## Technical Data Report Error Resolution Document

1. Originator: Roger J. Henning	2. Date: 06/27/08	3. ERD No. TDR-CRW-GS-000001 ERD 02
4. Document Identifier: TDR-CRW-GS-000001 REV 02 ICN 01 and TDR-CRW-GS-000001 ERD 01	5. Document Title: Yucca Mountain Site Description and Technical Data Report Error Resolution Document

Figure 4-23(a). Known or Suspected Quaternary Faults and Other Notable Local Faults within 100 km of Yucca Mountain (Addresses CR 2656, comments 8, 9, 10, 11, 12)

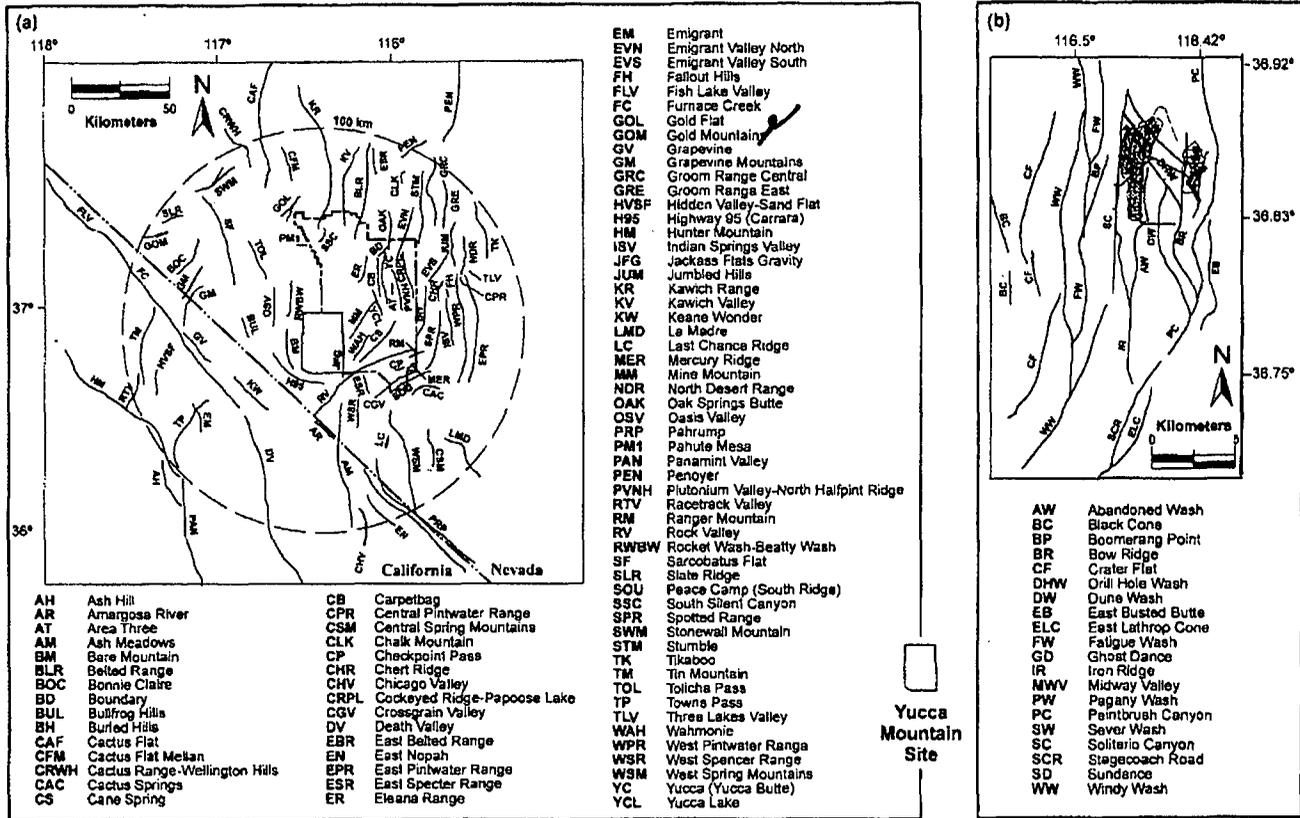
Technical Data Report Error Resolution Document, TDR-CRW-GS-000001 ERD 01, (LLR.20080423.0019) indicates that the name of the "Gold Mountain Fault" should be changed to "Gold Mountains Fault". This does not appear to be correct as multiple sources indicate that the name "Gold Mountain Fault" is correct. See, for example, Piety 1996 [DIRS 106540] Pages 77a through 77c; BSC 2004 [DIRS 168030], Figure 6; CRWMS M&O 2000 [DIRS 151968], Figure 2-8; and Anderson 1999 [DIRS 185574].

1. For consistency of fault names between the SAR and the YMSD, Figure 4-23 should reverse the change made by ERD01 and return "Gold Mountains" to "Gold Mountain". The YMSD Figure 4-23 is changed to "Gold Mountain" (CR 12203). In addition, for traceability, added reference to Anderson 1999 [DIRS 185574].

1. Figure 4-23[a] from TDR-CRW-GS-000001 ERD 01 (all other corrections in ERD 01 are valid except for "s" removed from "Gold Mountains" and addition of reference.)
2. Table 4-8 from TDR-CRW-GS-000001 REV02 ICN01 (corrected in the text of ERD01 but not transparent to license application)
3. Page 3-106 from TDR-CRW-GS-000001 REV02 ICN01 (corrected in the text of ERD01 but not transparent to license application)

Source: Faults included in the probabilistic seismic hazard analyses (CRWMS M&O 1998 [DIRS 103731]) and/or considered relevant by Pezzopane (1996 [DIRS 106524], Table 11-1); **Anderson, 1999 [DIRS 185574]**
